**Virginia Board of Housing and Community Development
CODES AND STANDARDS COMMITTEE
2024 CODE CHANGE CYCLE – BOOK 2, PART 1
May 11, 2026**

Tab 2 – USBC Proposals Recommended by the General Stakeholder Workgroup as Consensus for Approval

FIGURE 1609.5 TORNADO-PRONE REGION

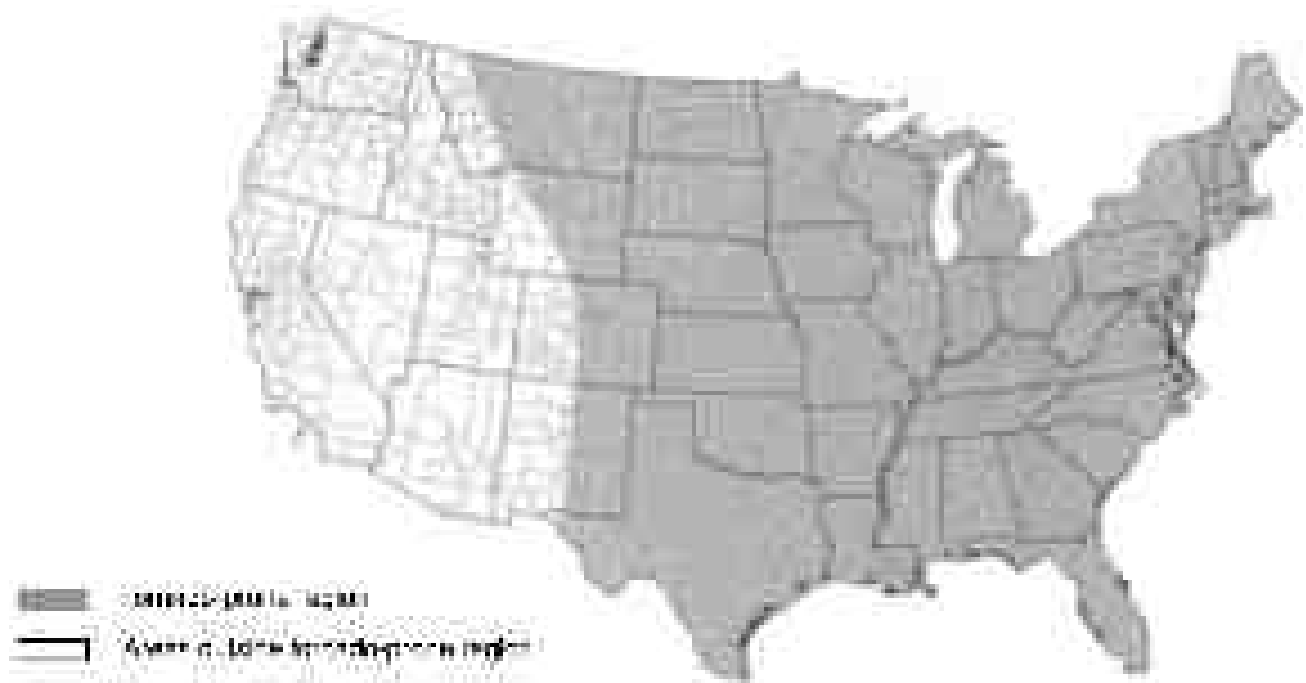
G. Add Figure 1609.5 Tornado-Prone Region to the IBC.
